Amendments to the Drawings:

Annotated Sheet Showing Changes

REMARKS/ARGUMENTS

Fig.4

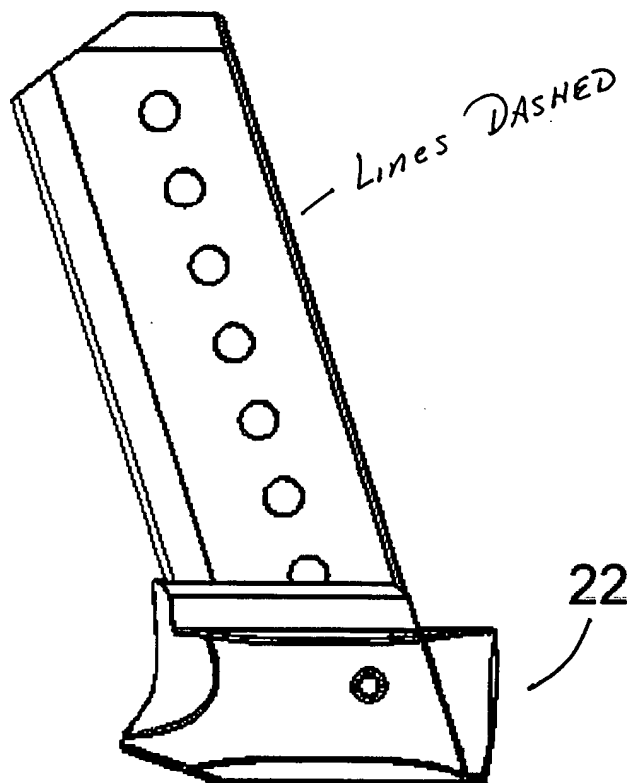
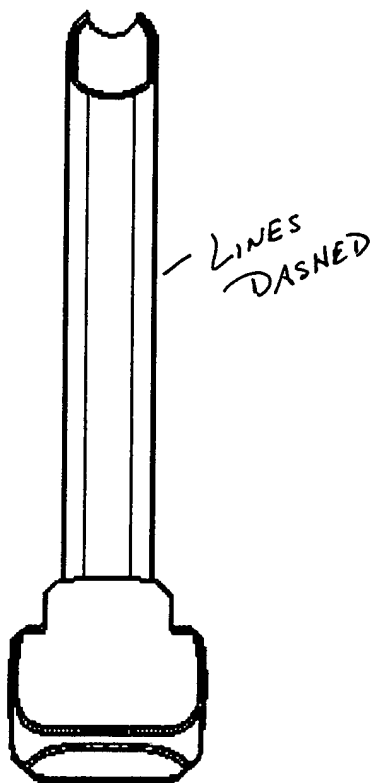
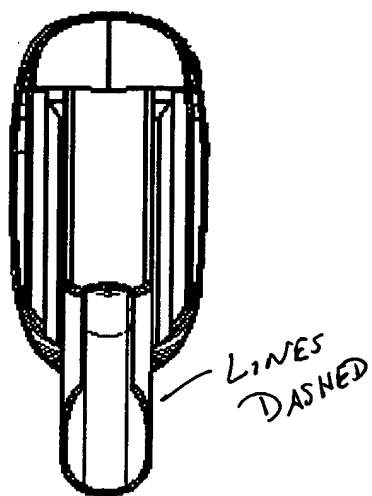
The attached sheet of drawings include changes to Fig.s 1,4 and 5. Fig. 1 has element 20 removed. Fig.s 4 and 5 have now dashed the figures that are pre-existing and not part of the invention.

Applicant has more clearly defined the claims to refer to a device attached to an extended length magazine that enables that magazine to more effectively interact with a handgun. Applicant has also modified the drawings to more clearly identify the device from the pre-existing magazine and handgun. The pre-existing magazine and handgun as illustrated are now consistently dashed in the drawings.
